Customer Services Bulletin
10/12/2020

Kitchen drawer gas ventilation hole - Product Modification Notice

MODEL: All Advance (Series I & II) & Alliance (Series I & SE) motorhomes

Y-CER-SOP-STD-P-SP-0043

Opp 2	Operation Description:	Visual Aid:
-------	------------------------	-------------

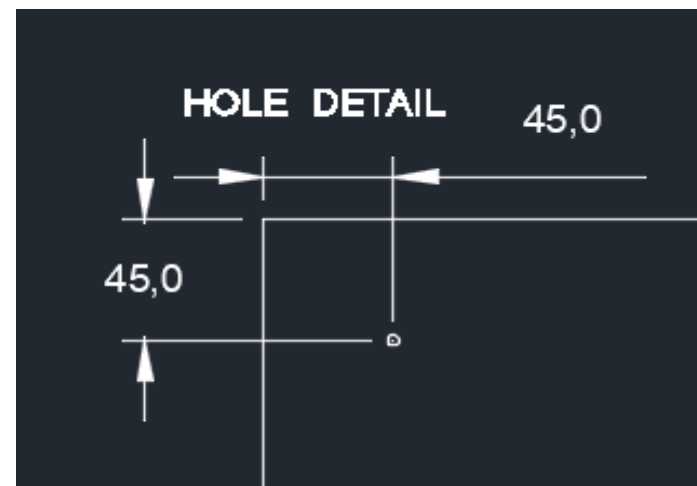
We would like to advise you that during ongoing quality assessment of our product we have identified a possible issue relating to the absence of a gas ventilation hole in certain kitchen drawers fitted in our Advance and Alliance motorhome ranges. In a number of instances, it has been identified that the required ventilation hole in the drawer located underneath the Thetford combination oven and grill has not been drilled out.

Drill a 4mm hole through the base of the drawer in the rear left hand side of the drawer base 45mm in from the back of the drawer and 45mm in from the left hand side of the drawer.

4MM DRILL
